EPC STORMWATER REVIEW COMMENTS  
IN ORANGE BOXES WITH BLACK TEXT

PCD PROJECT NO: PPR2232 & MS232

PROJECT  
FALCON STORAGE PARCEL  
PART W 1/2 SEC. 1, T.13S., R.65W., 6TH P.M.  
EL PASO COUNTY

SHT. NAME  
GRADING AND EROSION CONTROL PLAN

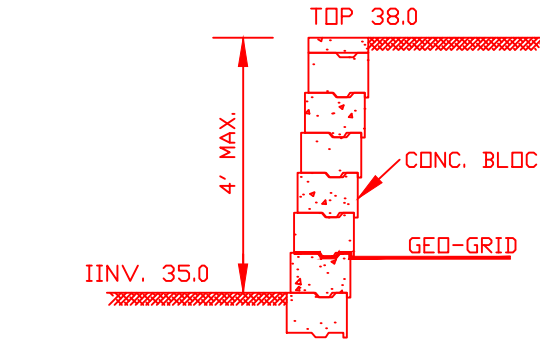
change to "Water Quality" this is not a detention pond. unresolved.

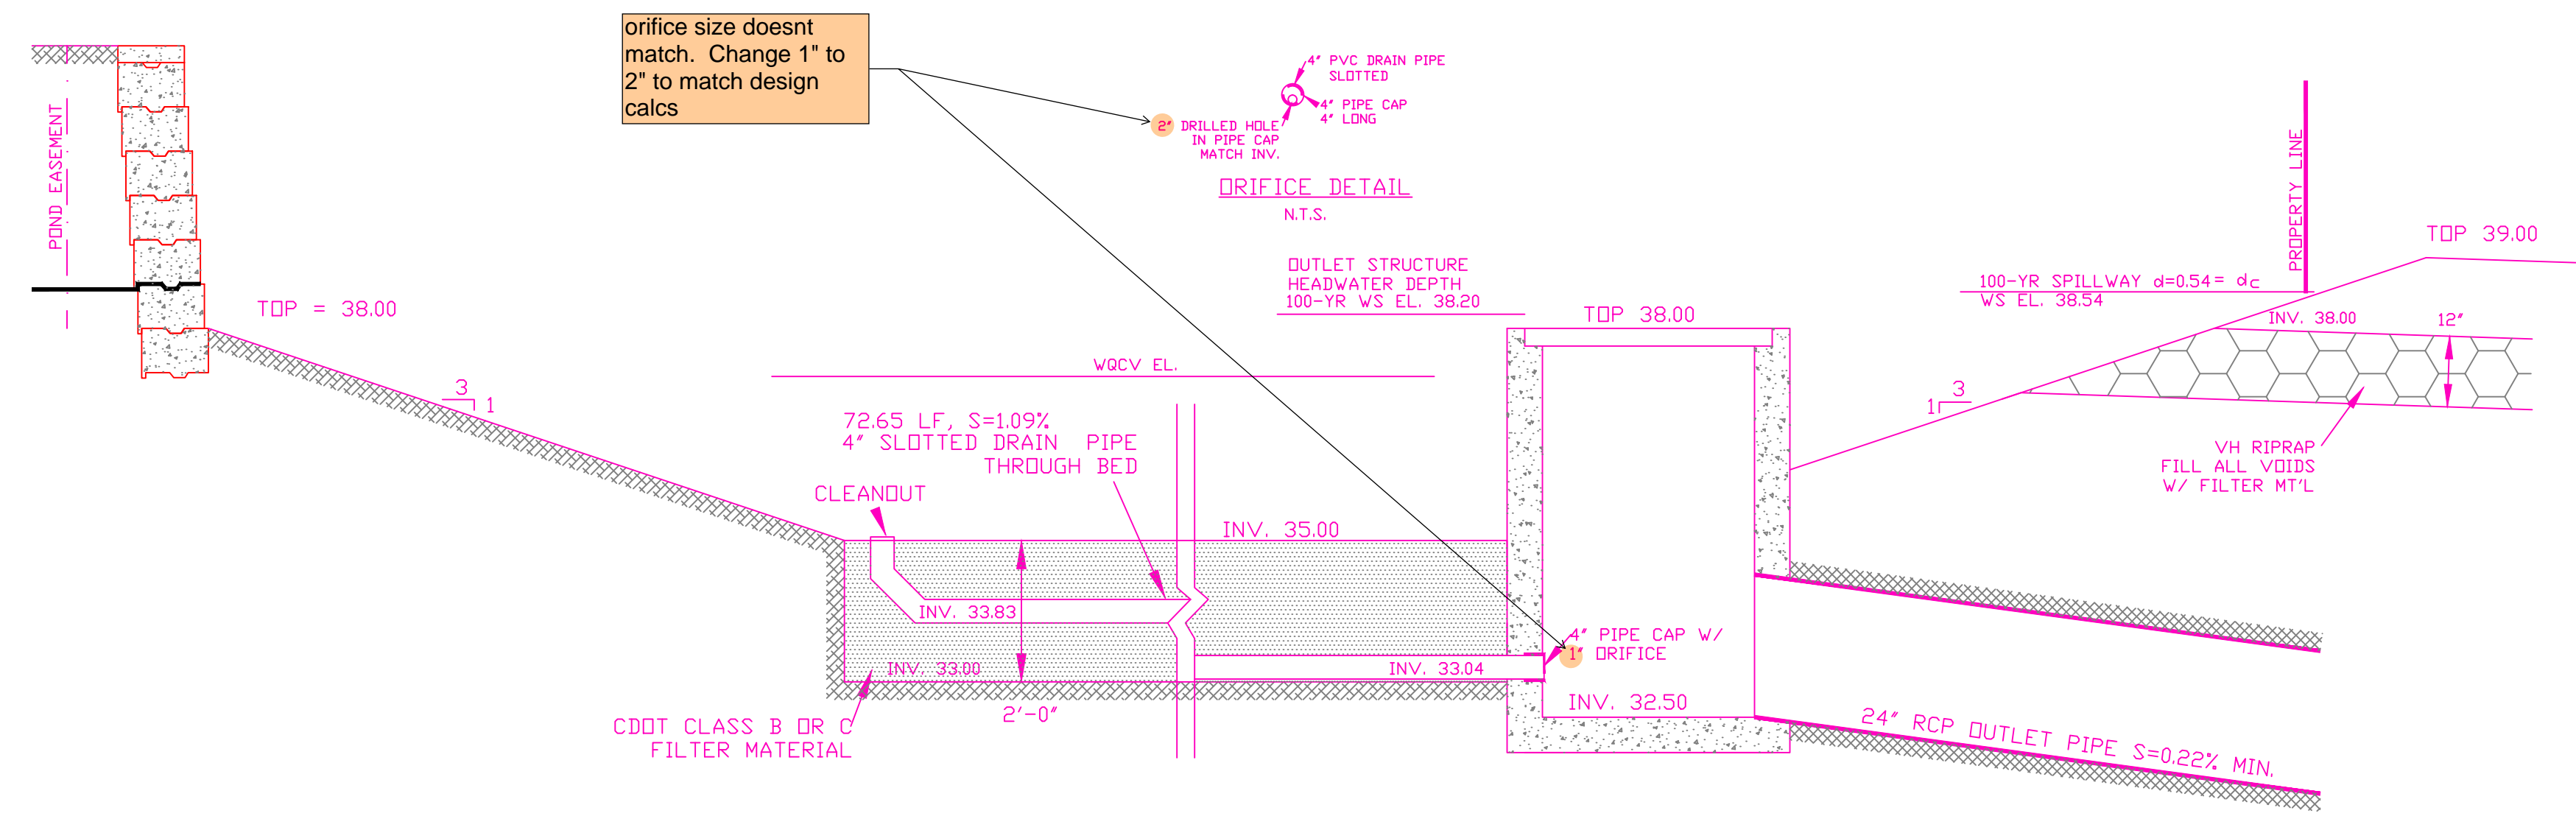
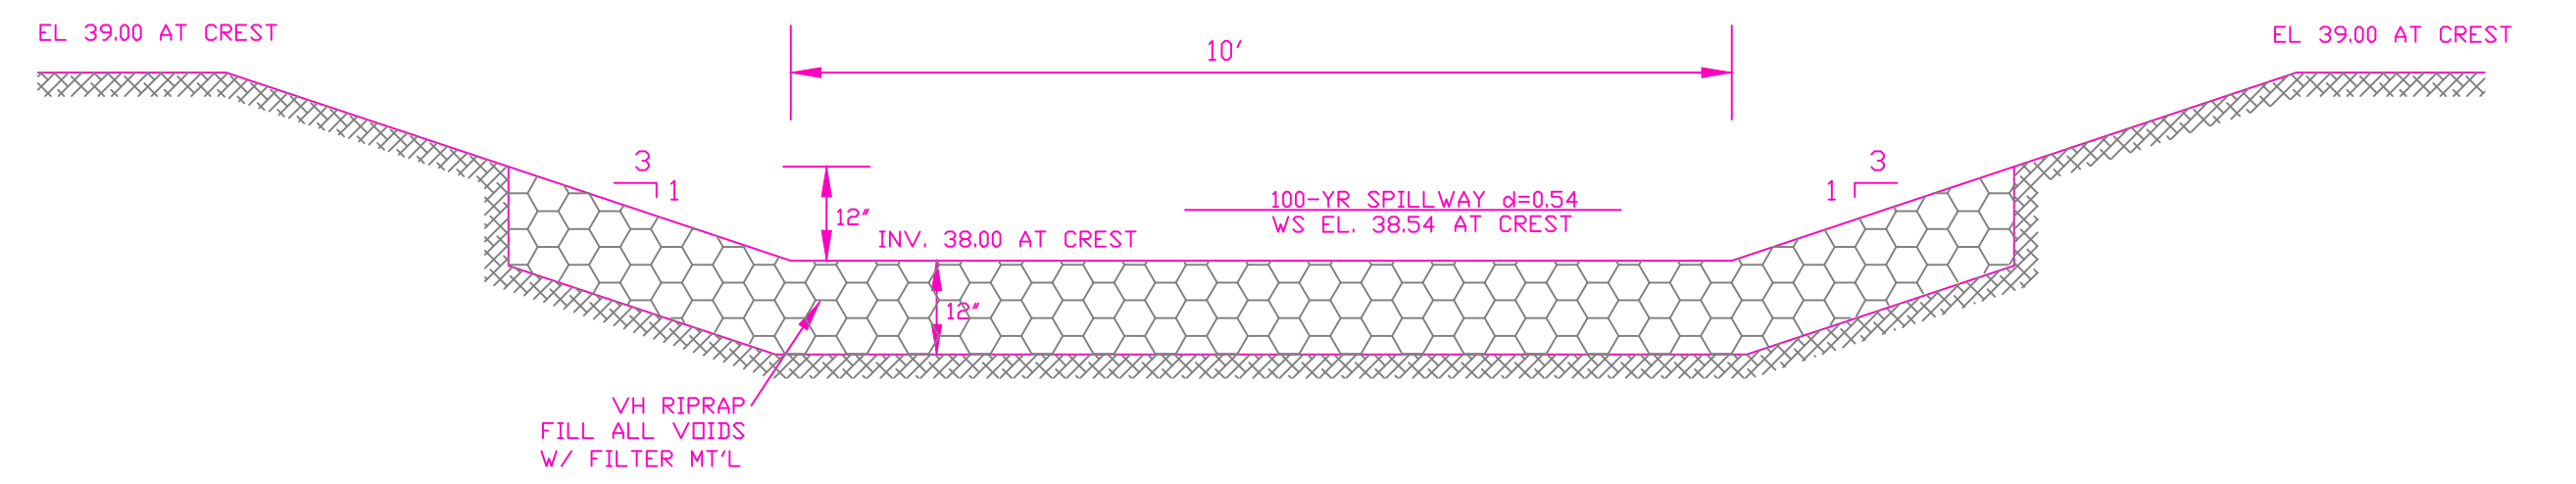
orifice size doesnt match. Change 1" to 2" to match design calcs

SHT. NO.  
 GRADING AND EROSION CONTROL PLAN

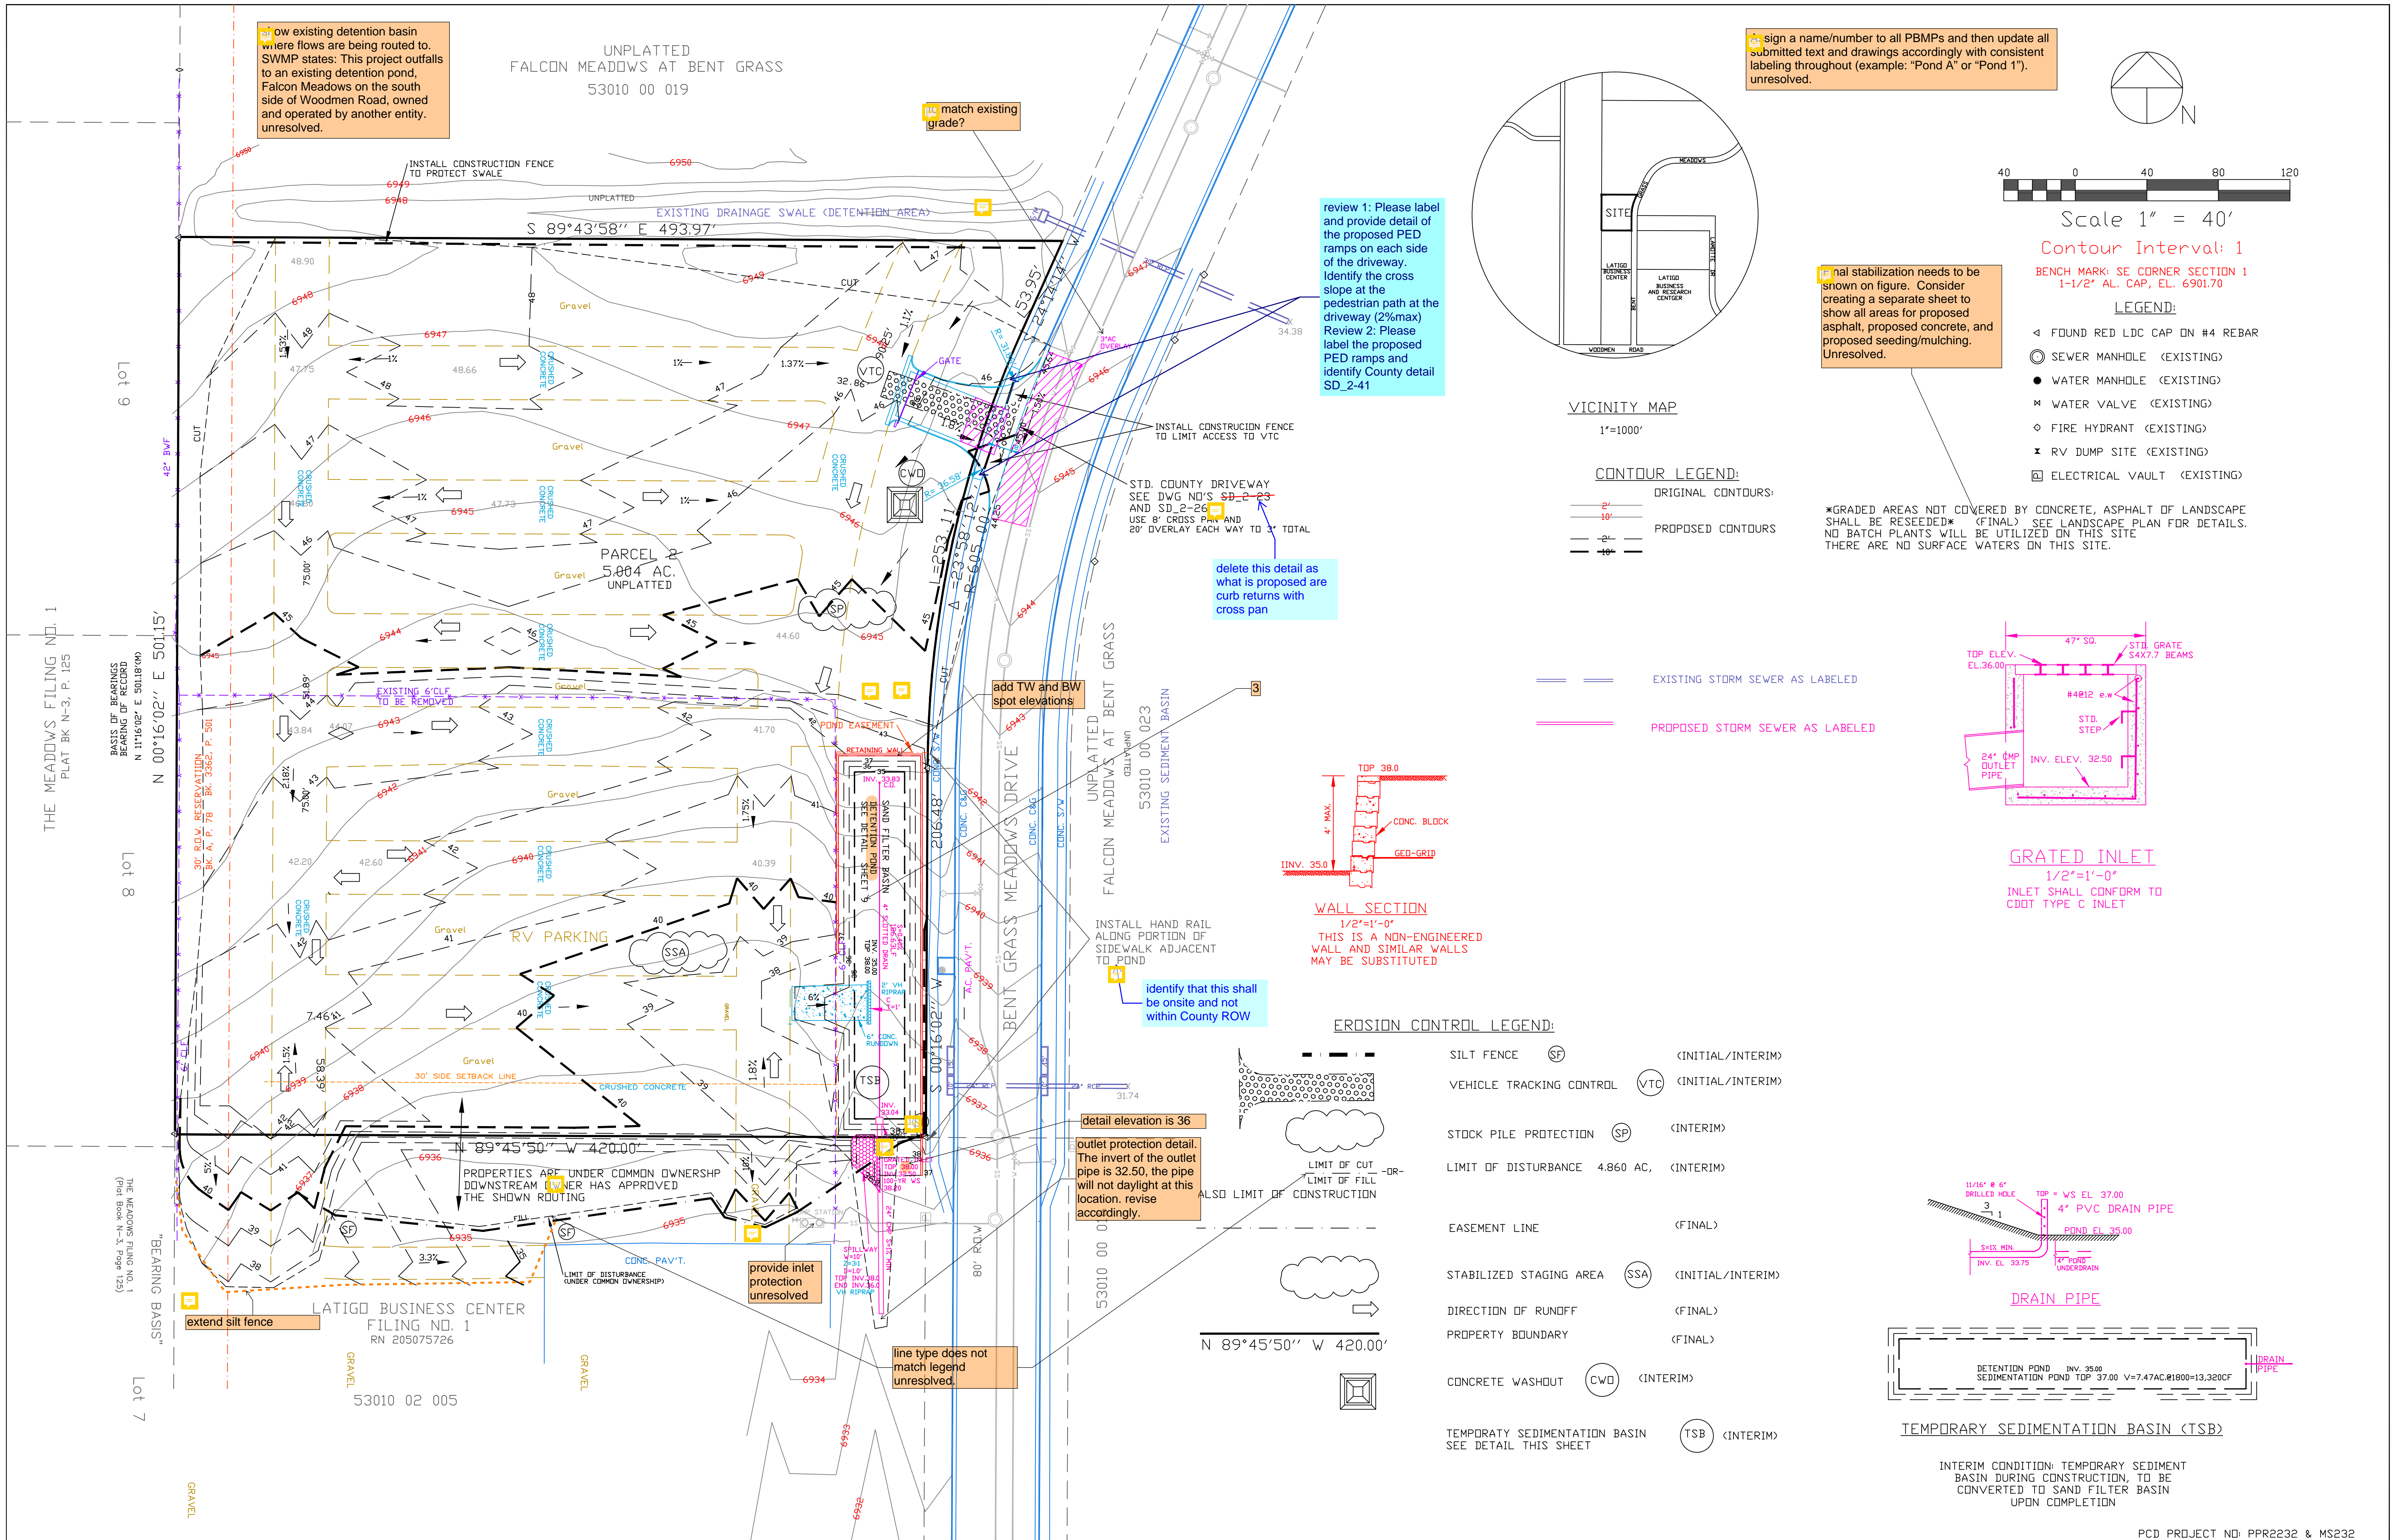
Low existing detention basin where flows are being routed to SWMP states: This project outfalls to an existing detention pond, Falcon Meadows on the south side of Woodmen Road, owned and operated by another entity. unresolved.

Sign a name/number to all PBMPs and then update all submitted text and drawings accordingly with consistent labeling throughout (example: "Pond A" or "Pond 1"). unresolved.

review 1: Please label and provide detail of the proposed PED ramps on each side of the driveway. Identify the cross slope at the pedestrian path at the driveway (2%max) Review 2: Please label the proposed PED ramps and identify County detail SD\_2-41

Final stabilization needs to be shown on figure. Consider creating a separate sheet to show all areas for proposed asphalt, proposed concrete, and proposed seeding/mulching. Unresolved.
